# **Clarification #1**

To drawings and specifications for

## **Cemetery Sewer Rehabilitation for the City of Sidney**

### **Soil Borings**

JOB NO. 67-252 LOG OF SOIL BORING NO. S-25

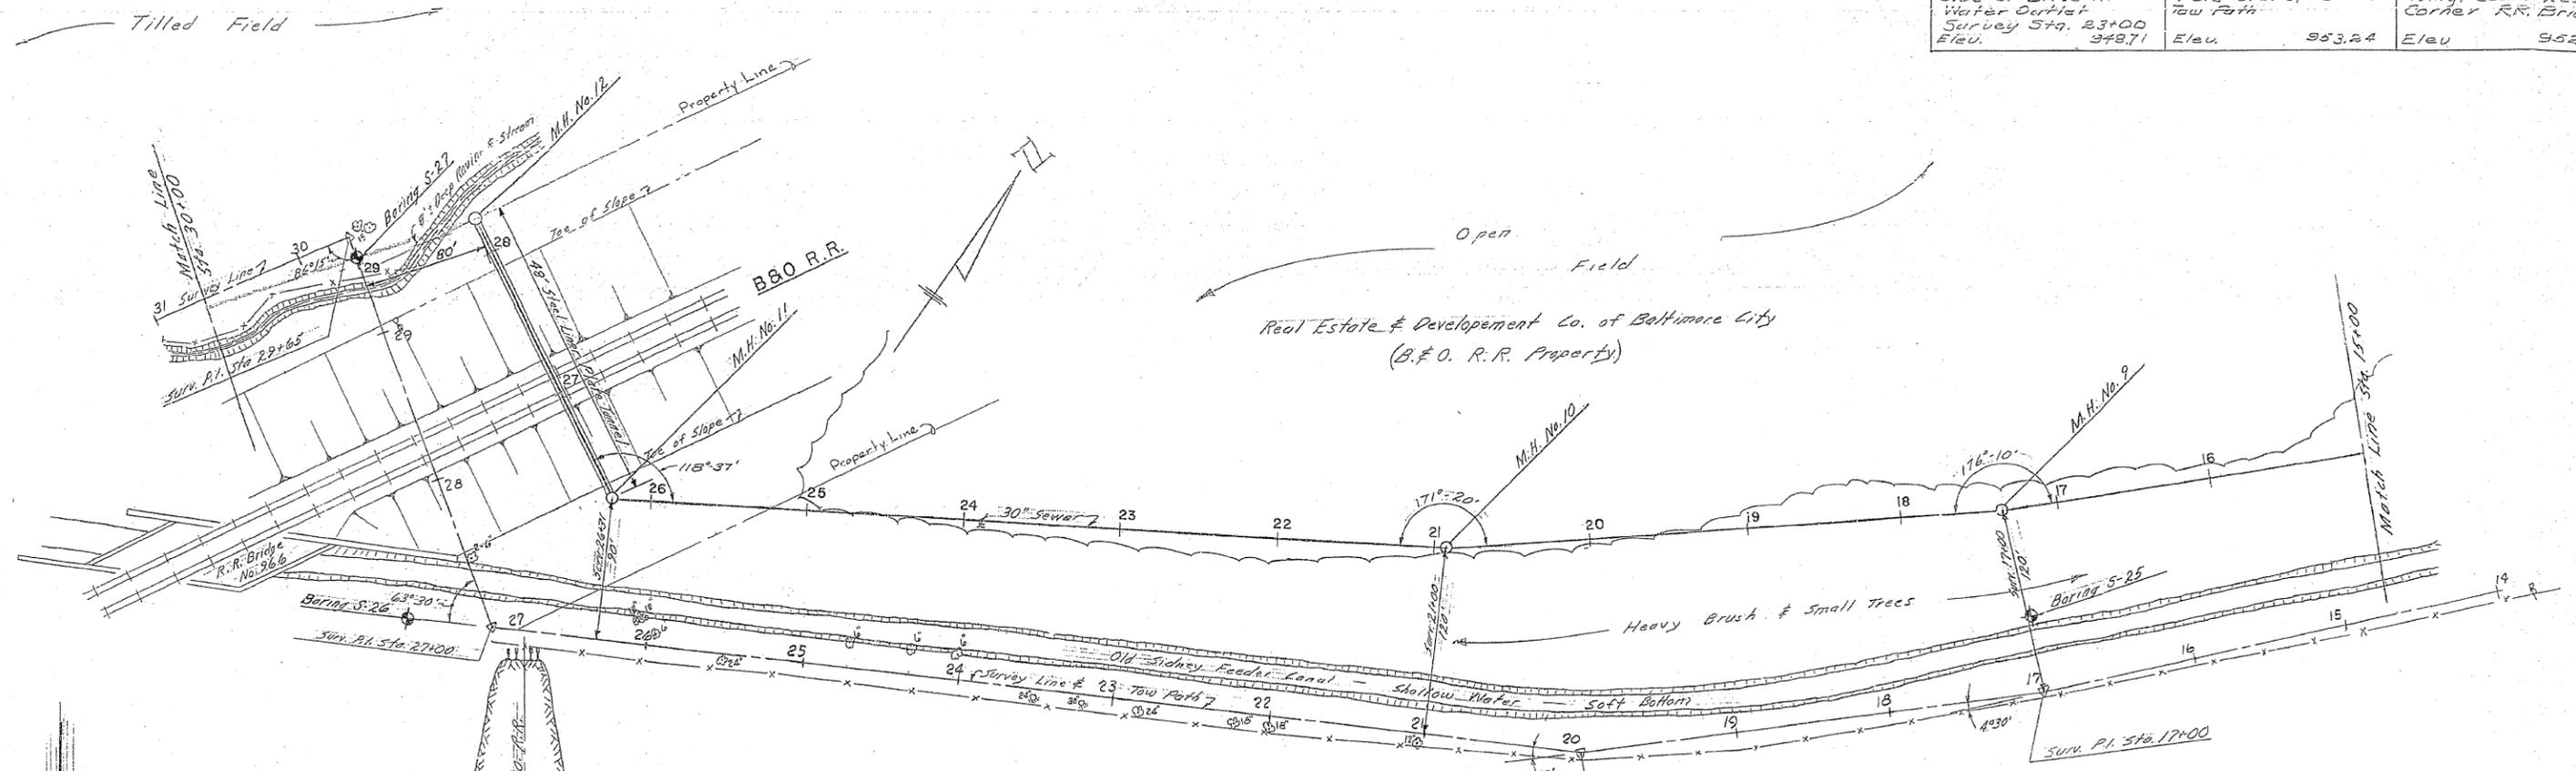
Soil borings were not done for this project; however, the attached 1967 soil boring log from the Canal Interceptor sewer installation along with the plan sheet that shows its location is being added to the bid package for your reference. The attached soil boring was taken relatively close to the manhole that is being excavated for the drop structure and does not encounter bedrock.
